# **SERVICE PROCEDURE**

**G-07501**  
**April 2007**

**SUBJECT: SAFETY RECALL (U.S., EXPORT)  
BATTERY CABLES on certain 9000 Models built  
4/1/2002 thru 12/25/2006 with Caterpillar® Engines**

**Figure 2**

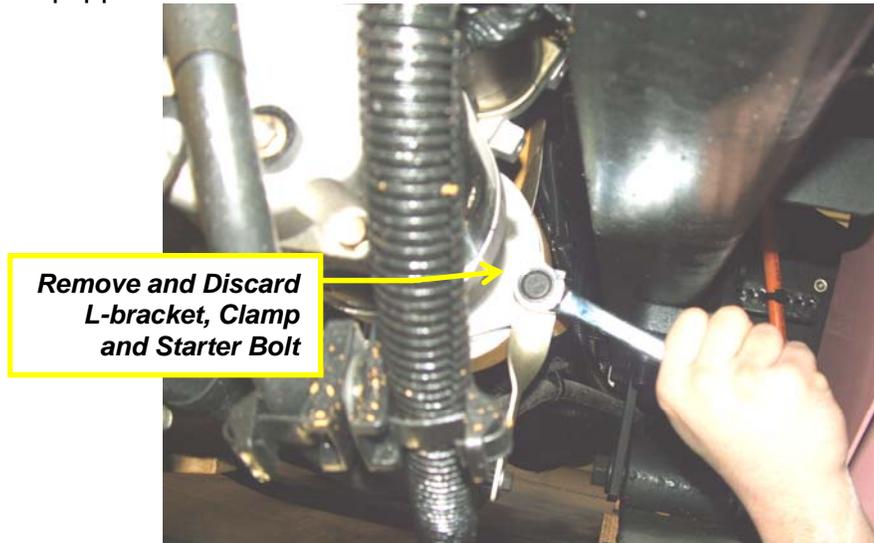
4. Remove and discard starter L-bracket, clamp and 12-point starter bolt, if equipped.

**Figure 3 – Belly Band Looking Forward**

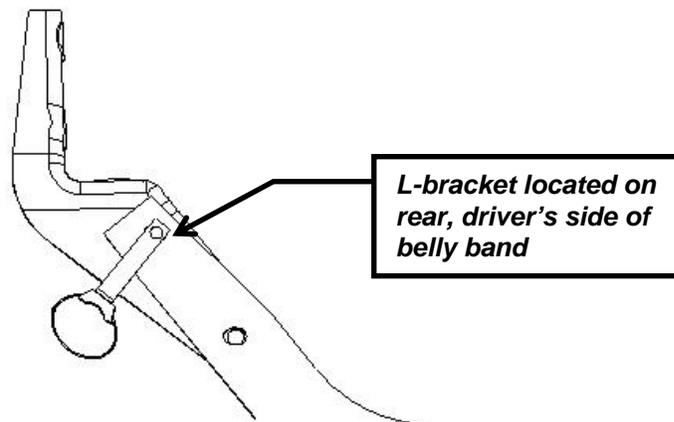
5. If vehicle was built with feature code **001GTC** - *CROSSMEMBER, FRAME TIE Deep Drop; Mounted Between Front Cab Mounting Brackets*, also referred to as a 'belly band,' remove and discard the L-bracket and clamp connected to the rear of the belly band.

Figure 12

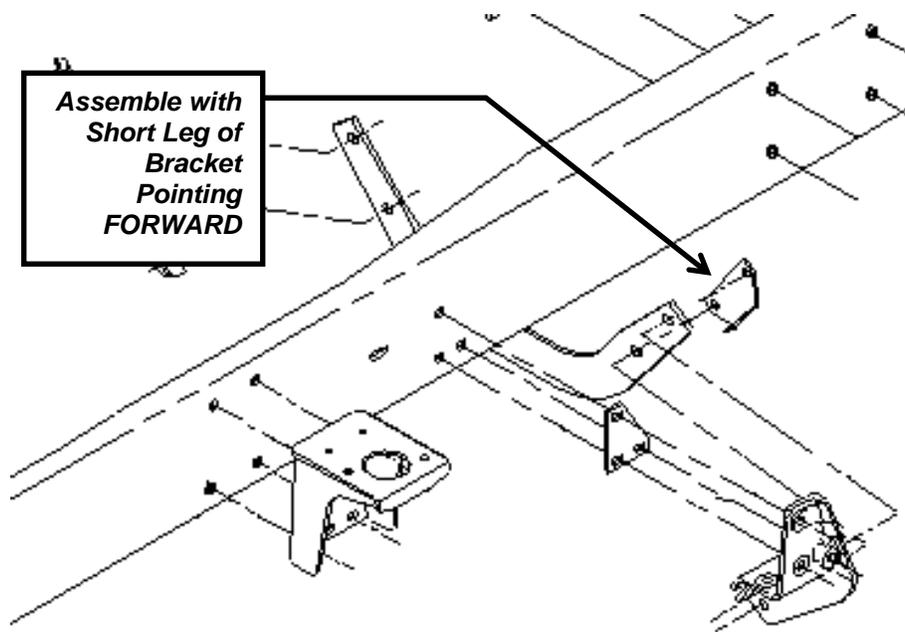
20. Install new belly band bracket on rear side of belly band using existing hardware. Torque bolts to **220-240 LbF-Ft (298-325Nm)**.

**Figure 29 --  
Chafing may occur between Engine Block Ground and Newly Located Positive cables.**

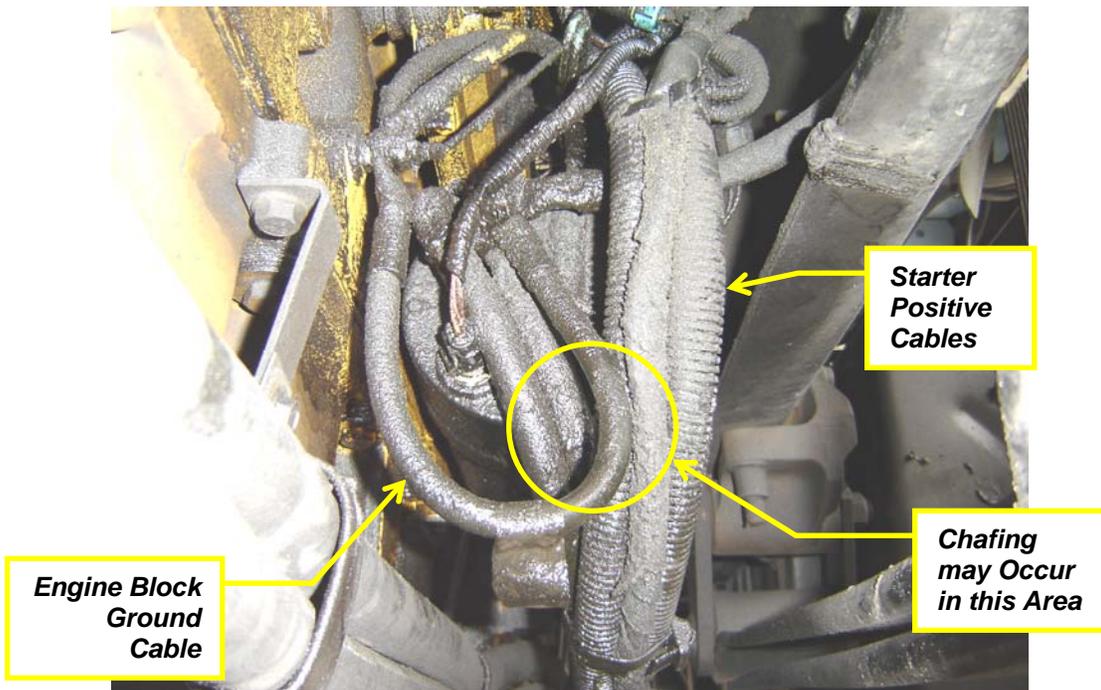
**TO PREVENT CHAFING OF THE POSITIVE CABLES AGAINST THE ENGINE BLOCK GROUND CABLE (SEE FIGURE 29), PLEASE ENSURE ENGINE BLOCK GROUND CABLE IS CLOCKED IN THE DOWNWARD (6 O'CLOCK) POSITION, SEE FIGURE 30.**

- ***If contact or chafing of the ENGINE GROUND cable against the Battery Cables is present, rotate and tighten the ground cable on the starter terminal so it is straight down (6 o'clock position) and not contacting the starter positive cables, see figure 30.***

**Figure 31 – FRAME Ground Inspection**

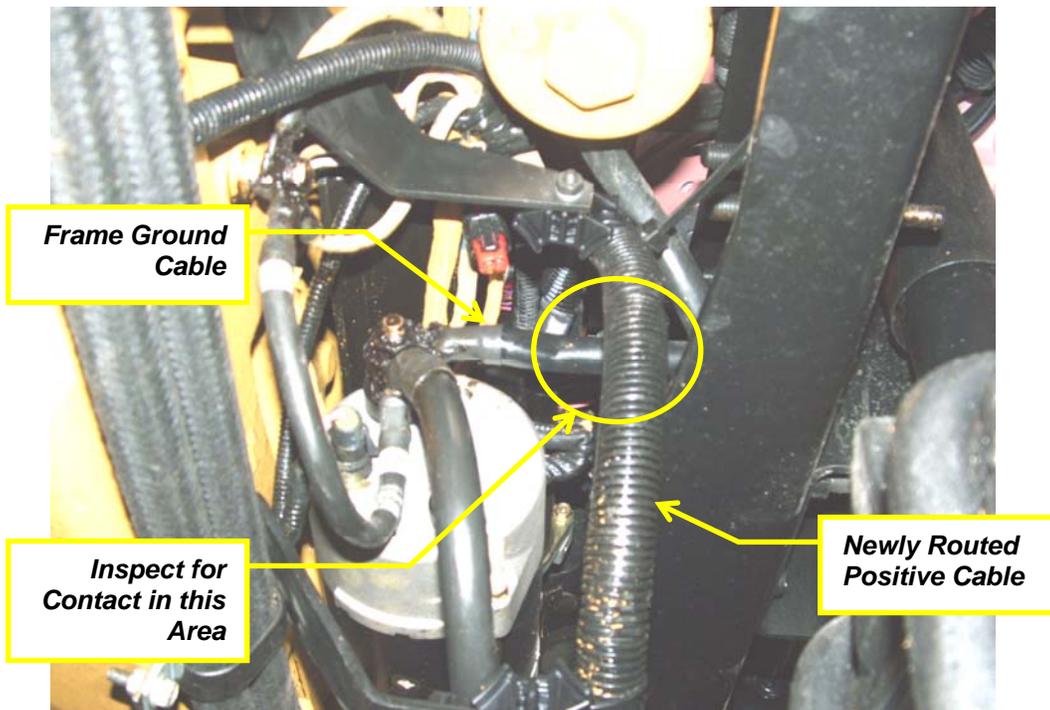
**TO PREVENT CHAFING OF THE POSITIVE CABLES AGAINST THE FRAME GROUND CABLE (SEE FIGURE 31), PLEASE ENSURE FRAME GROUND CABLE IS NOT IN CONTACT WITH THE NEWLY ROUTED POSITIVE CABLES, SEE FIGURE 32.**

Figure 32 – Frame Rail Removed for Clarity

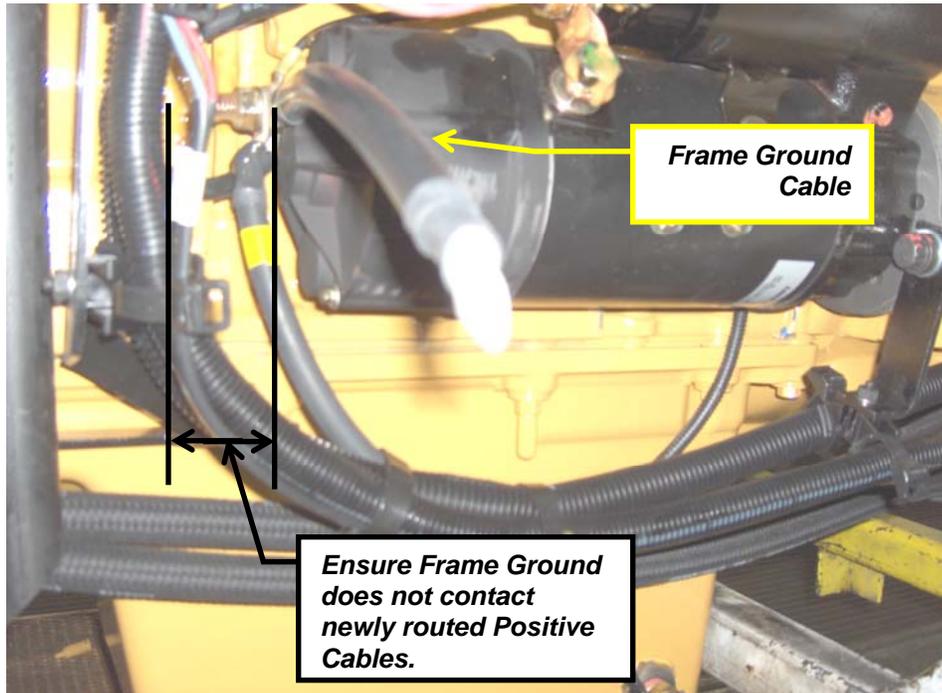
- Ensure cables are not in contact.
